ASB-1025

Service Bulletin

Subject: AT-50 Blows ACCY Fuse in TS-50S (Part 2) **Date:** June 25, 1993

(Supercedes ASB-1010 dated April 30, 1993)

**X53-3470-00 D/4
Foil Side View
Figure 1**

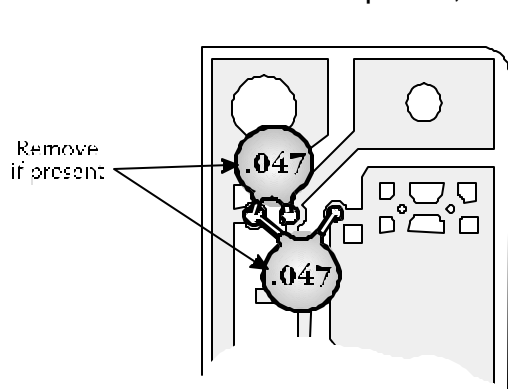
1. Remove the top and bottom covers from the antenna tuner.
2. Locate X53-3470-00 D/4 (It is attached to the top left side of the chassis with the foil side up.)
3. Remove the two .047 μ F capacitors shown in figure 1 if they are present.
4. Cut the foil and add one of the toroidal inductors as shown in figure 2.
5. Turn the tuner over and locate capacitor C123 and C124, as shown in figure 3.
6. Move the capacitors (or add new capacitors) to the locations shown in figure 3.
7. Cut the foil path and add the remaining toroidal inductor as shown in figure 3.
8. Remove Jumper W106 as shown in figure 3. (Note remove the jumper from the component side of the board.)
9. Add a jumper from the ATG foil to W104 as shown in figure 3.
10. Replace the top and bottom covers.
